AIRWORTHINESS DIRECTIVE

TYPE AFFECTED: LS 4 and LS 4a up to serial number 4340

SUBJECT: Inspection and modification of the dive brake control circuit.

No. 4020

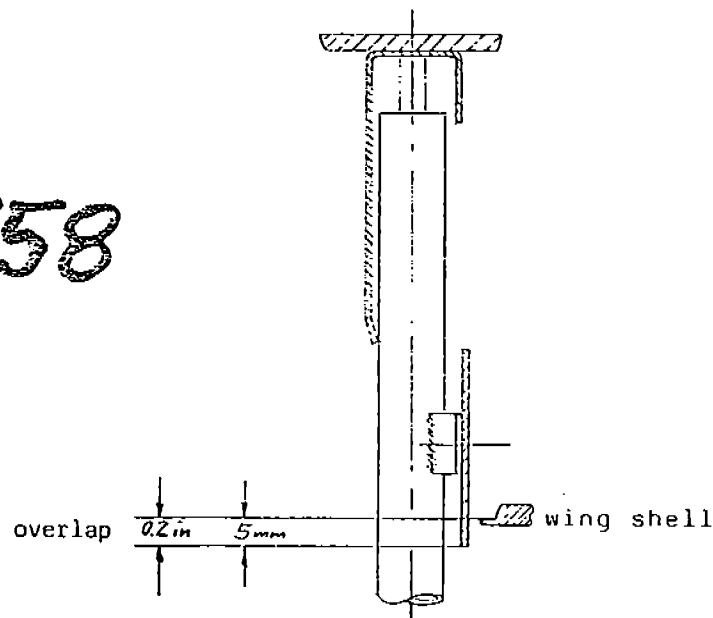
- 1) Assemble sailplane
- 2) With air brakes fully extended, measure overlap between lower blade and wing shell central to levers. When overlap is below 5 mm (0.2 in) proceed according to step 3.
- 3)a. Retract air brakes until overlap is at least 5 mm (0.2 in) at both wings
- b. Check extending height at inner lever, minimum is 150 mm (5.91 in). If below minimum, contact manufacturer.
- c. Rivet stop to air brake pushrod in cockpit from approx. 45° below horizontal such, that main bulkhead reduces travel to yield required overlap

Material: Stop 4R6-15, Steel blind rivet 4x10, (drill dia. 4.1 mm, DN 20)
